ITEM: 6.5	COMMITTEE OF ADJUSTMENT REPORT SUMMARY MINOR VARIANCE APPLICATION FILE NUMBER A011/23 UNITS 1 TO 5 (INCLUSIVE) ON BLOCK 3, PLAN 65M 4761 (HUNTINGTON RD)
------------------	---

**COMMITTEE OF ADJUSTMENT REPORT
MINOR VARIANCE APPLICATION
A011/23
UNITS 1 TO 5 (INCLUSIVE) ON BLOCK 3, PLAN
65M 4761 (HUNTINGTON RD)**

ITEM NUMBER: 6.5	CITY WARD #: 1
APPLICANT:	Nashville Developments (South) Inc.
AGENT:	TACC Developments
PROPERTY:	Units 1 to 5 (inclusive) on Block 3, Plan 65M 4761 (Huntington Rd)
ZONING DESIGNATION:	See Below
VAUGHAN OFFICIAL PLAN (2010) DESIGNATION:	Vaughan Official Plan 2010 ('VOP 2010'): "Mid-Rise Mixed-Use," Volume 1, and "Mid-Rise Mixed-Use B," Volume 2, Section 12.7 Block 61 West – Nashville Heights
RELATED DEVELOPMENT APPLICATIONS:	None
PURPOSE OF APPLICATION:	Relief from the Zoning By-law is being requested to permit a reduce rear yard setback to the garage for Units 1 to 5 (inclusive) on Block 3, Plan 65M 4761. Increased maximum garage width is also required for Units 1 and 5 only. Relief is required to permit the construction of a proposed townhouse block.

SITE PLAN
 file name: 21014-SP-COA

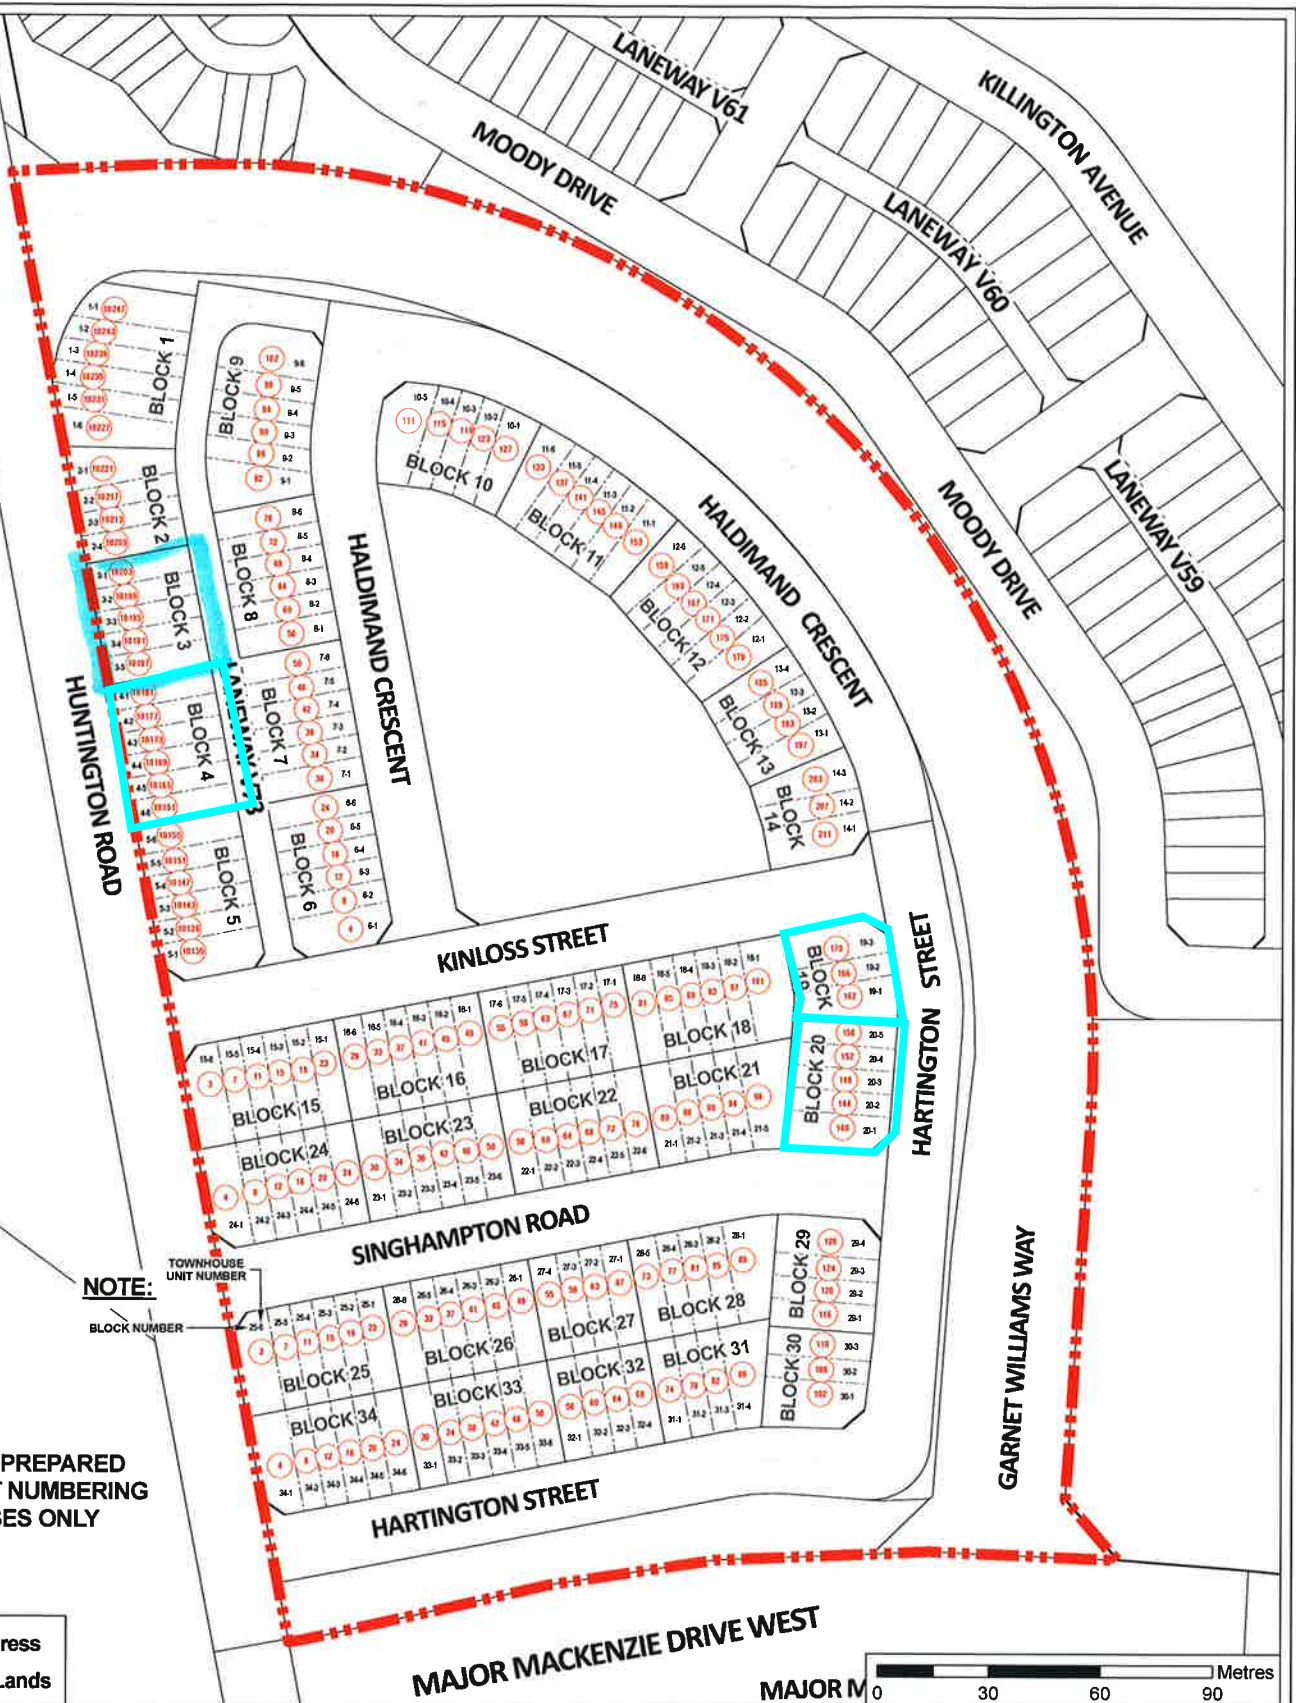
Zoning By-law 1-88		Variance requested
1	A minimum rear yard of 7.5 metres is required to the garage. Schedule "A3"	To permit a minimum rear yard of 1.0 metre to the garage.
2	A maximum garage width of 3.048 metres is permitted for lots less than a lot frontage of 11.0 metres and for corner lots greater than 14.0 metres. Schedule "A3" General Notes A.	To permit a maximum garage width of 5.54 metres Townhouse 1 and 5.

The Development Planning Department has no objection to the proposed variances for the attached garages. The attached garages are located at the rear of the dwelling, accessed by a laneway. Rear lane townhouses with attached garages by the nature of their design typically have modest rear yards. Laneways are typically more utilitarian in nature and characterized by built form close to the laneway. Most of the rear yard space will function as a driveway and is not usable outdoor amenity space. The proposed outdoor amenity space for the townhouses is placed within a courtyard between the front-facing portion of the townhome and attached garage. Units 2-4 have 2 parking spaces: one within an attached garage and one on a parking pad beside the garage. Units 1 and 5 are located on either end of the townhouse block and have sufficient room to accommodate a wider 2 car garage in lieu of a parking pad and garage combination. The proposed garages are also one-storey in height with no living space proposed above. As such, no adverse massing impacts are anticipated to the neighbouring properties.

Accordingly, the Development Planning Department can support the requested variances and is of the opinion that the proposal is minor in nature, maintains the general intent and purpose of the Official Plan and Zoning By-law, and is desirable for the appropriate development of the land.

The Development Planning Department recommends approval of the application.
